Capital Investment Committee

4. Consideration Of Change Order No. 6 To COF Contract No. 2017-0264 With Kiewit Infrastructure South Co, For The Water Reclamation Facility Modifications & Expansion Project.

Consideration Of Change Order No. 6 To COF Contract No. 2017-0264 With Kiewit Infrastructure South Co, For The Water Reclamation Facility Modifications & Expansion Project.

PROJECT: City of Franklin, Tennessee
Franklin WRF Modifications & Expansion Project

Figure CCA-32-1
(NTS)

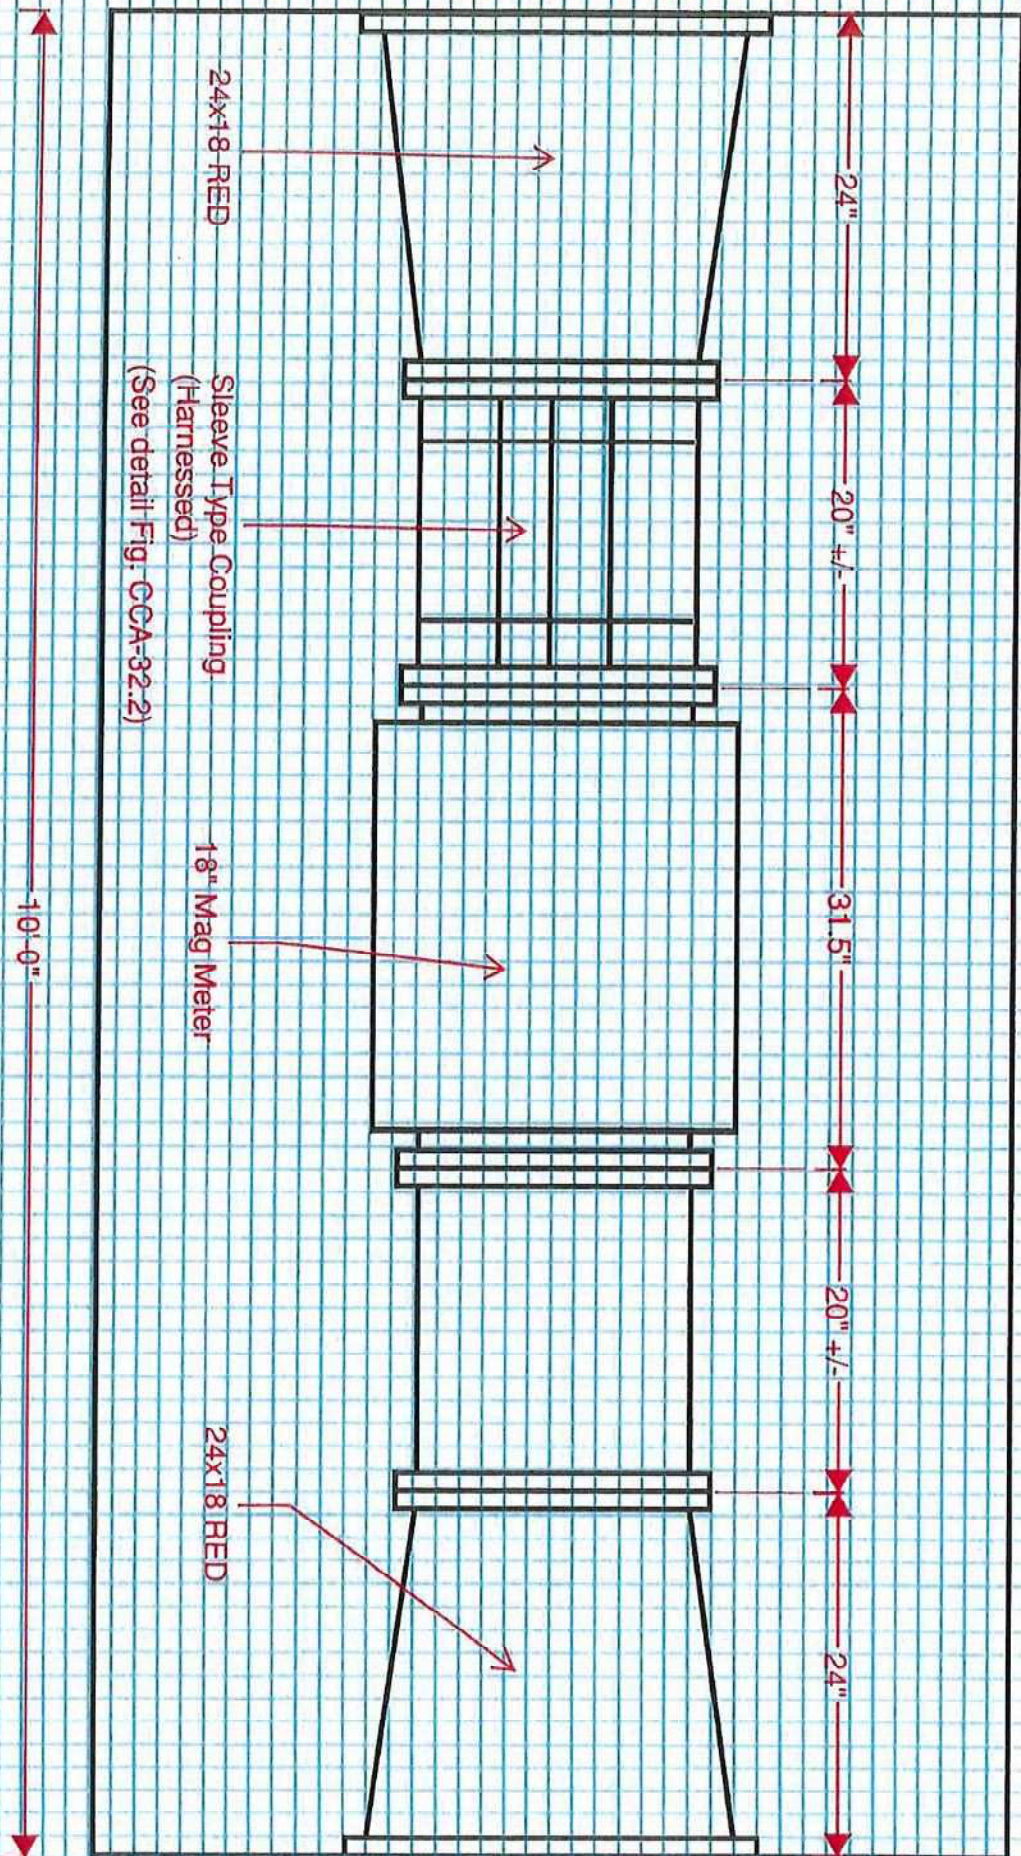
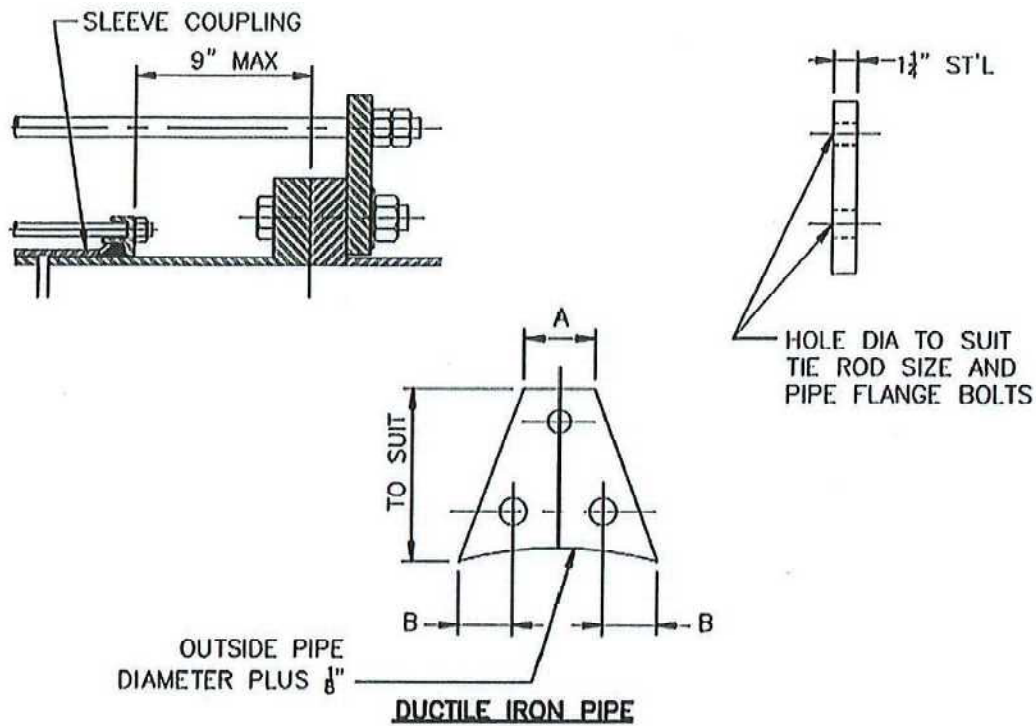
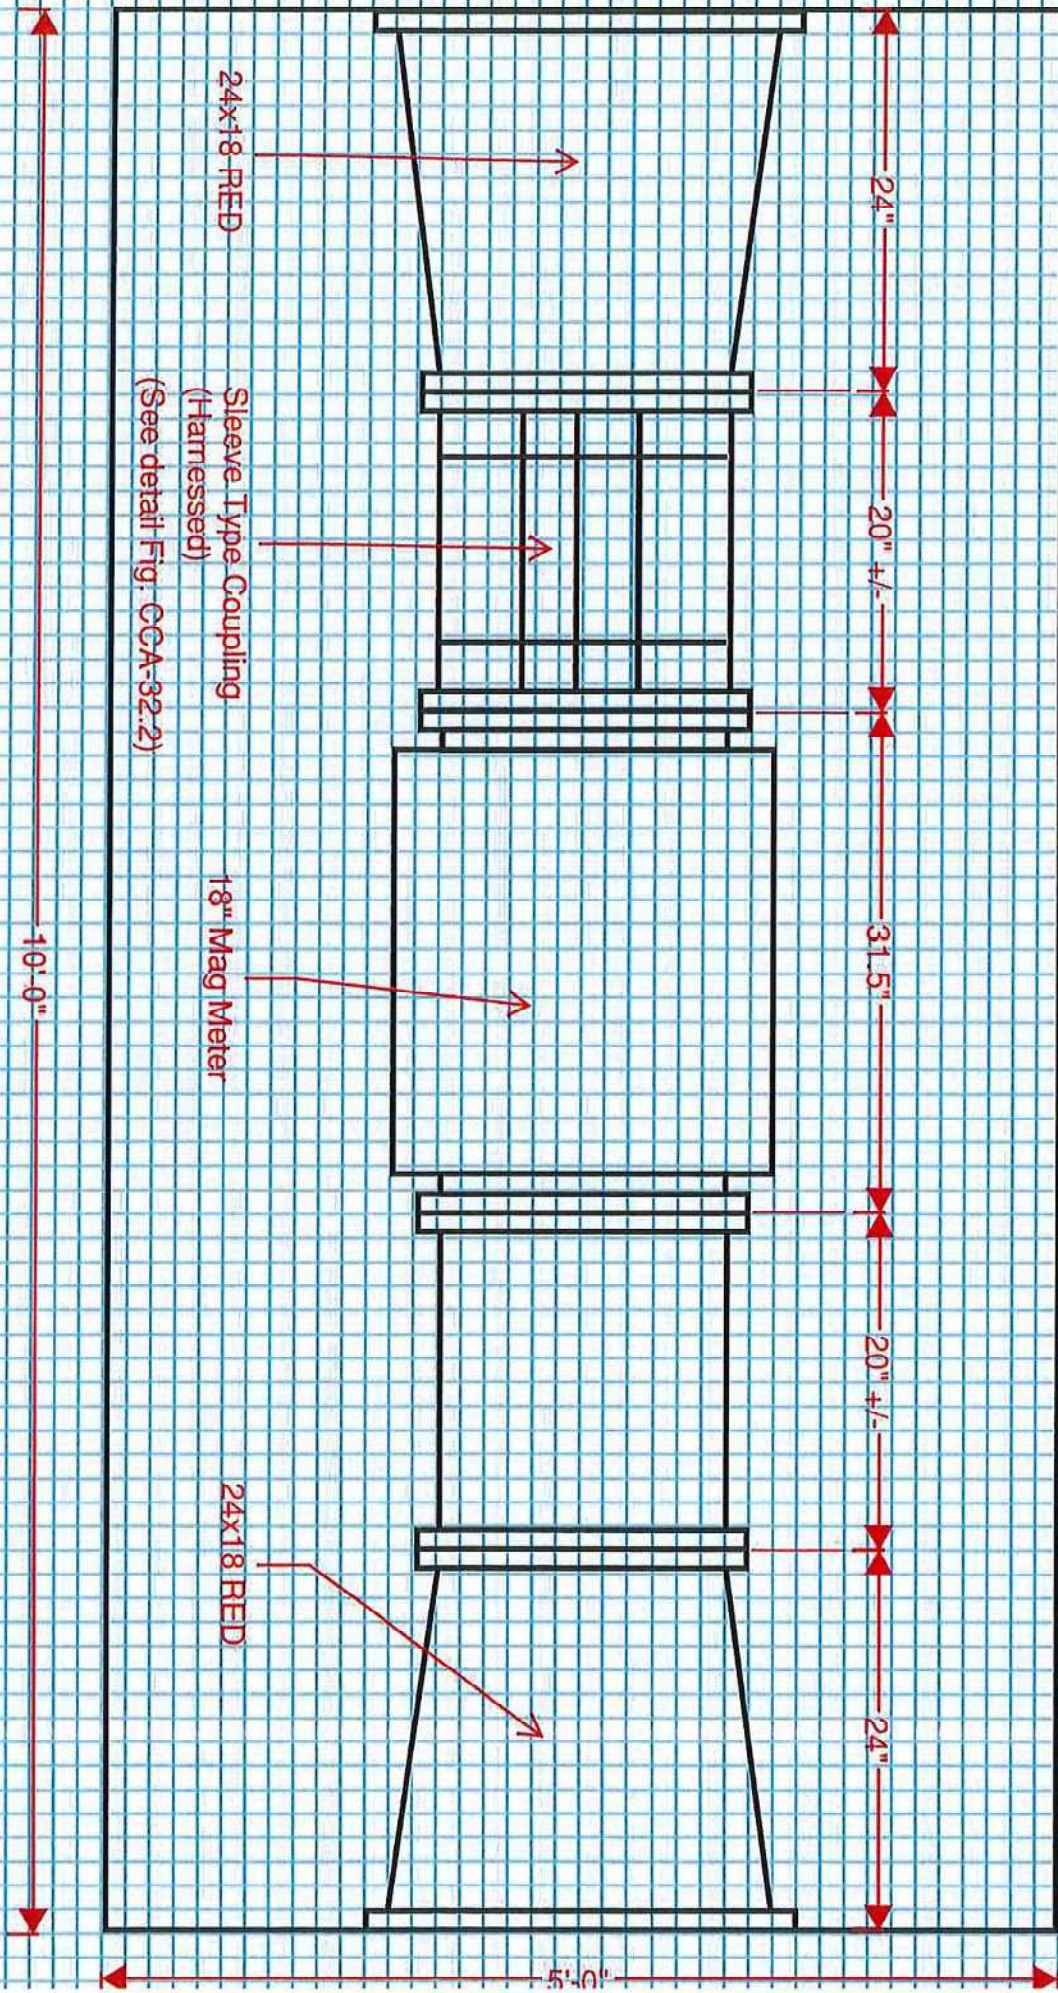
DESCRIPTION: Remove existing pipe, fittings and 10" magnetic flow meter from the Reclaimed Water Pump Station Effluent Flow Meter Vault. Install new 18" magnetic flow meter (FE/FIT-850), pipe and fittings generally as shown on Fig. CCA 32-1 attached. Include all work necessary to incorporate the signal from the new flow meter to the new PLC at the Reclaimed Water Pump Station and SCADA, reuse existing analog I/O points. Field verify all dimensions. Submit a disruption plan for this work for Engineer review. All work to take place Monday through Friday, 7am - 5pm. Provide min. 48 hours' notice prior to beginning the work.

FIG. CCA53-1

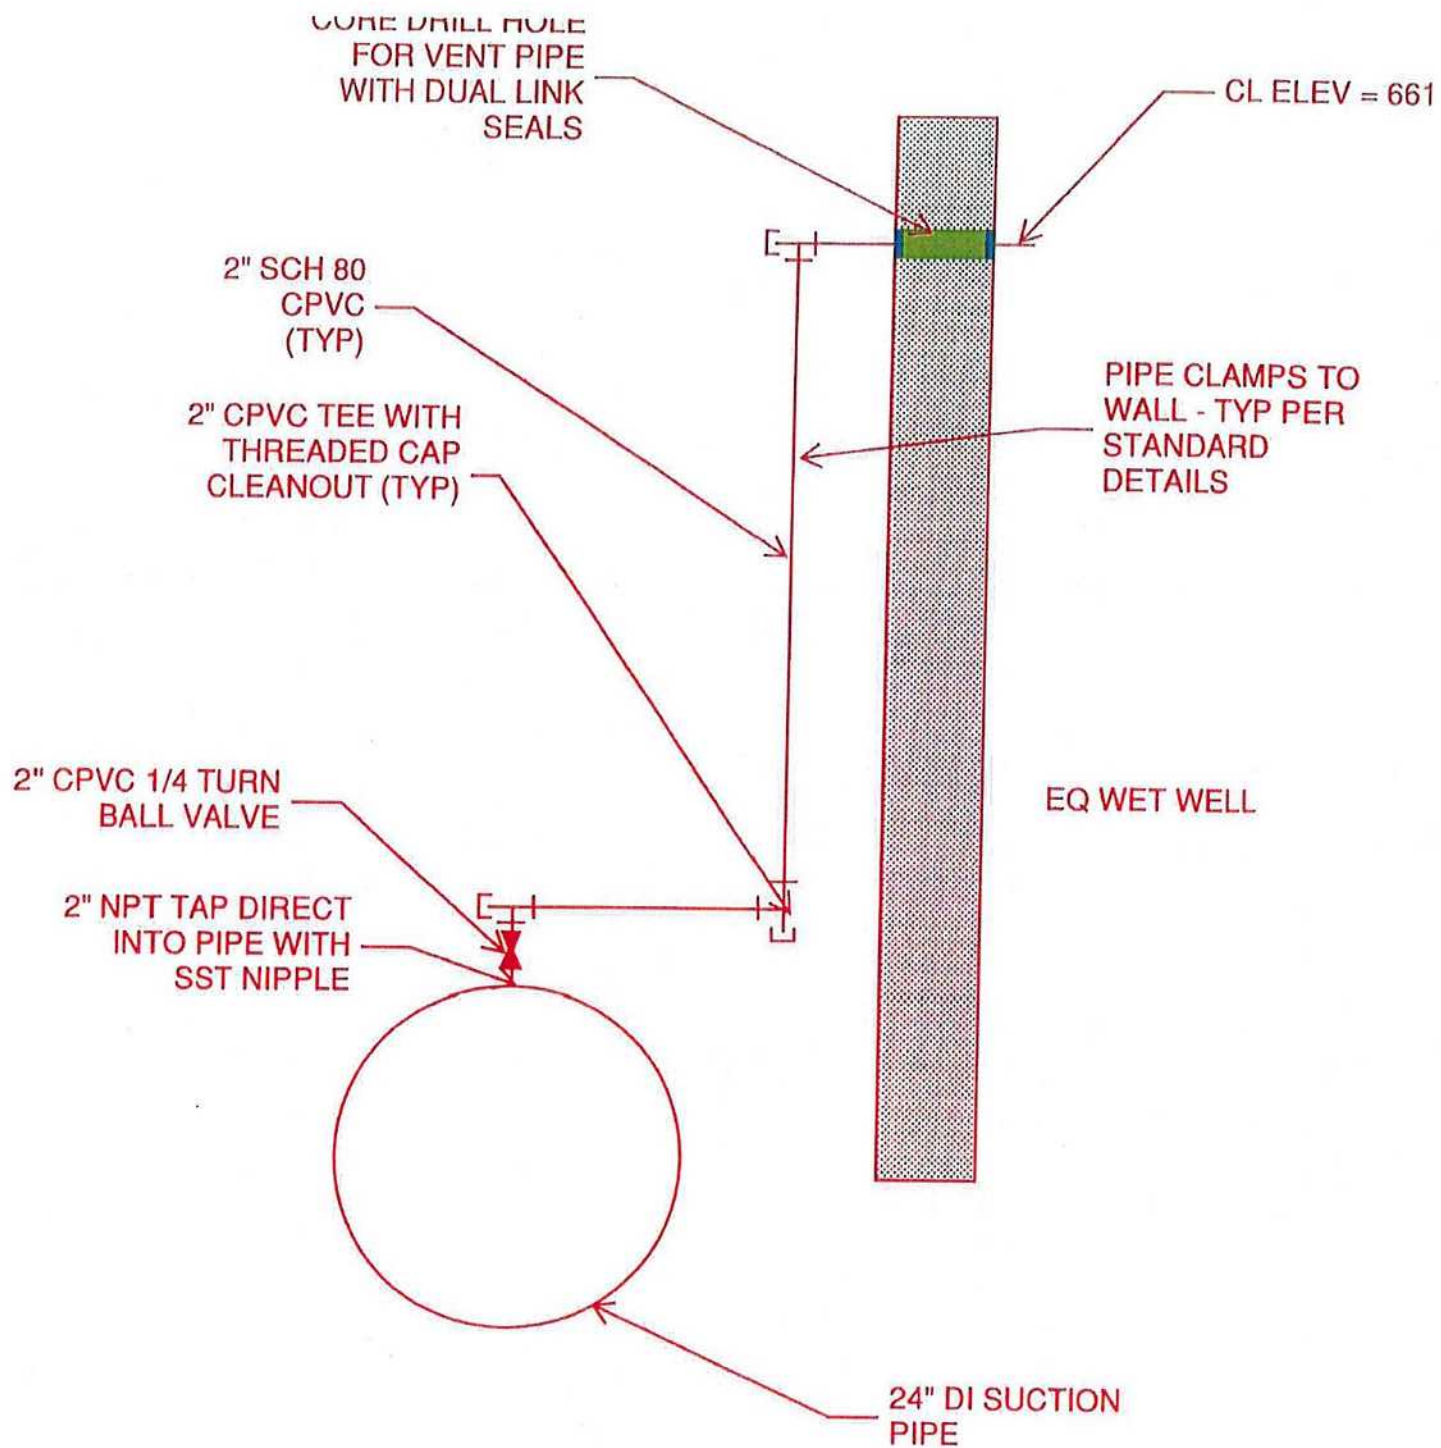
DESCRIPTION: Controls for the existing Reclaimed Water Pumping Station (RWPS) currently residing in the RWPS local control panel are to be transferred to new PLC-4 as shown on revised Sheets E-56 and I-21 attached. The existing local control panel is to remain as a terminal cabinet. The attached schematic for the existing panel and hand sketch are provided for informational purposes only and the Engineer does not guarantee accuracy. Contractor to investigate the as-constructed panel and reuse existing components to the extent necessary to provide the desired functionality. Provide pricing for this work for Engineer review.

RFI-275

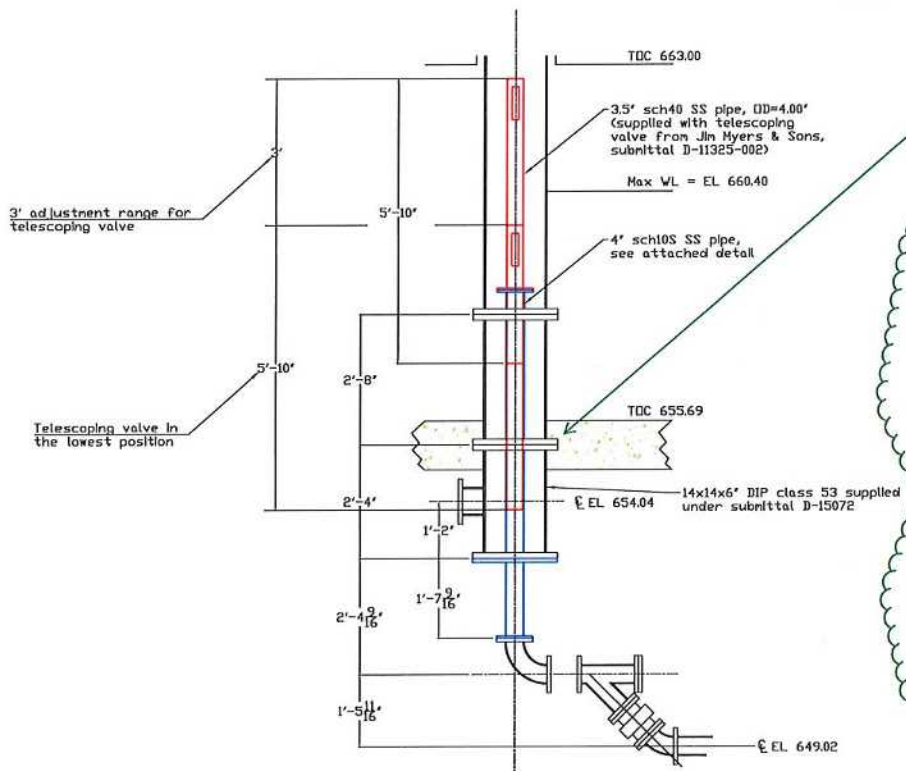
Is this acceptable for the center feed pipe?

This flange is embedded in concrete

Figure 1 – Existing Conditions of RAS Box

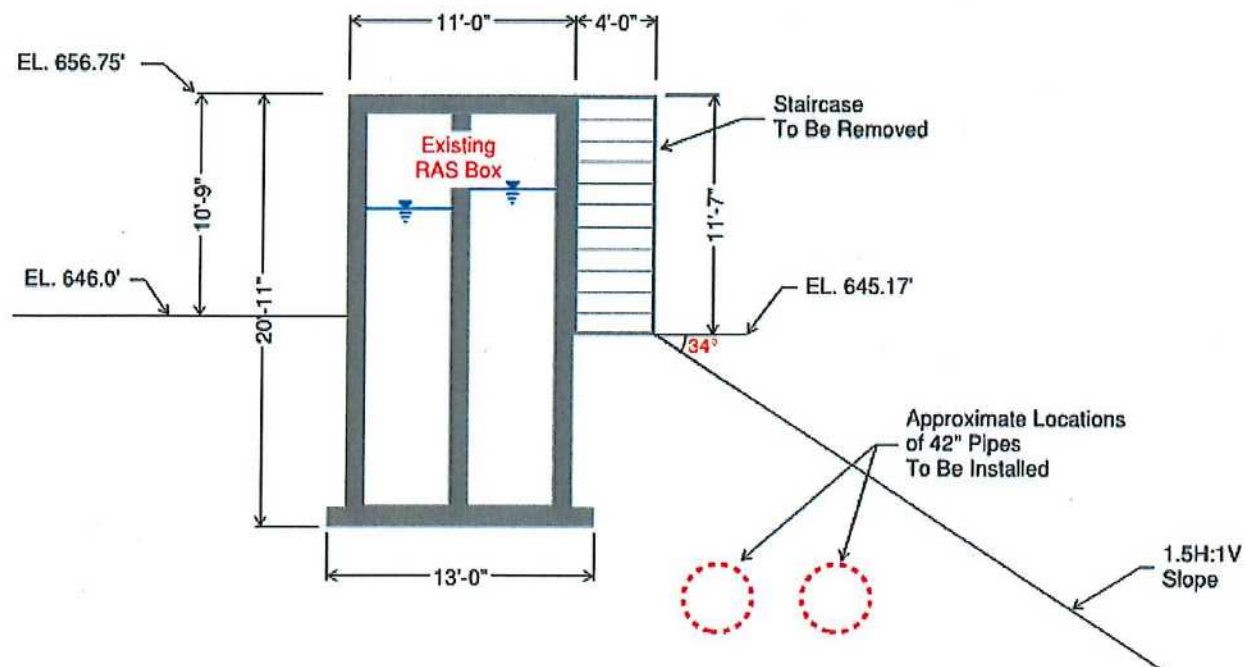
Per our communication with the project team and based on the RAS Box as-built drawings, we developed a cross section of the RAS Box locating next to an approximately 1.5H:1V slope in the existing condition (Figure 1). We understand that the existing staircase of the RAS Box will be removed prior to the temporary excavation for installation of the RWW-DI pipes. The approximate locations of the pipes as shown in red dashed lines were determined based on the sketch provided by the project team.

Figure 2 – Temporary Excavation and Soldier Pile and Lagging for Installation of 42-in RWW-DI Pipes

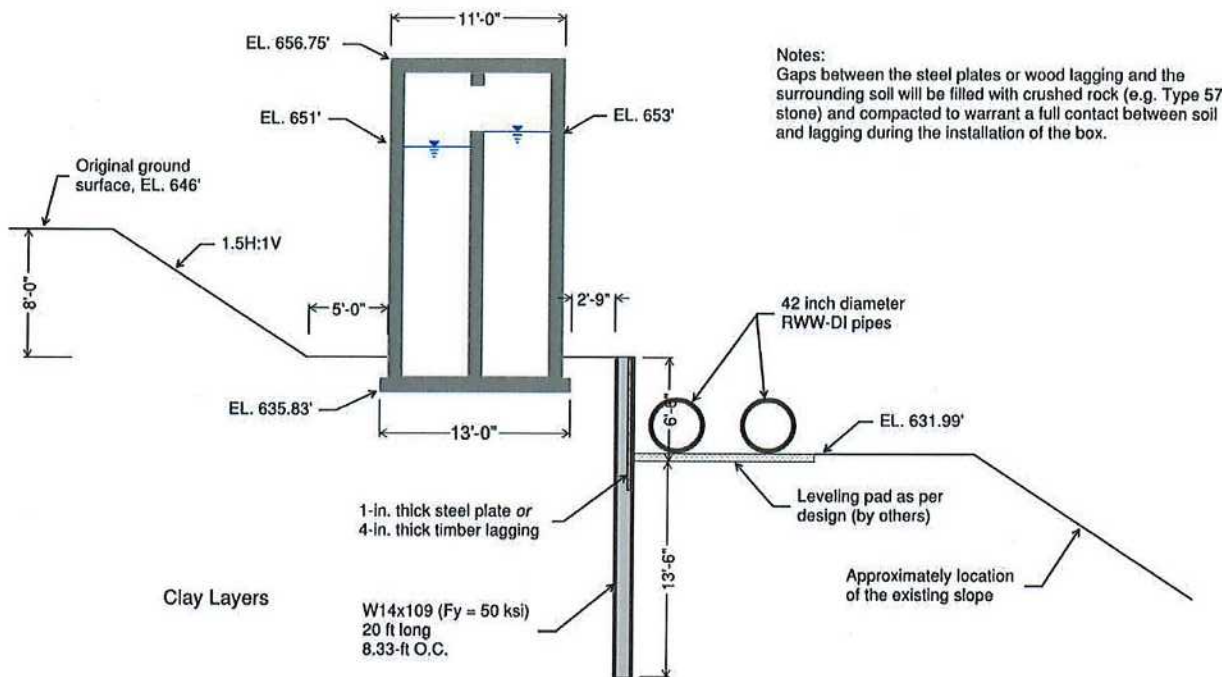
Based on our communication with the project team, we developed an excavation plan with the use of a SOE soldier pile and lagging for installation of the RWW-DI pipes (Figure 2). We performed bearing capacity checks for the RAS Box. The plan view of the SOE is shown in Figure 3.

Figure 1 - Proposed Shoring and RAS Dist Box Cross-section

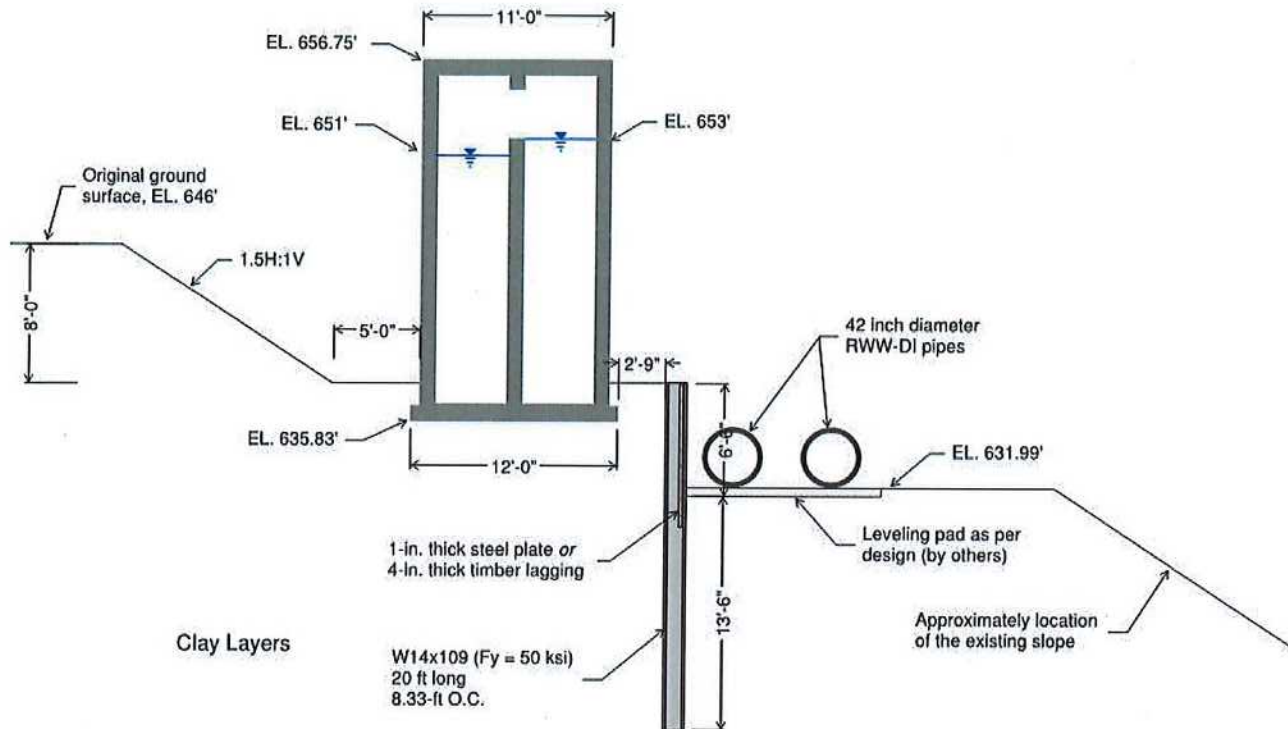
Design a soldier pile and lagging SOE to support the RAS Distribution Box for excavation to install the RWW-3 line (Figure 1). This is the second SOE option following the first SOE option of trench box issued on April 30, 2020.
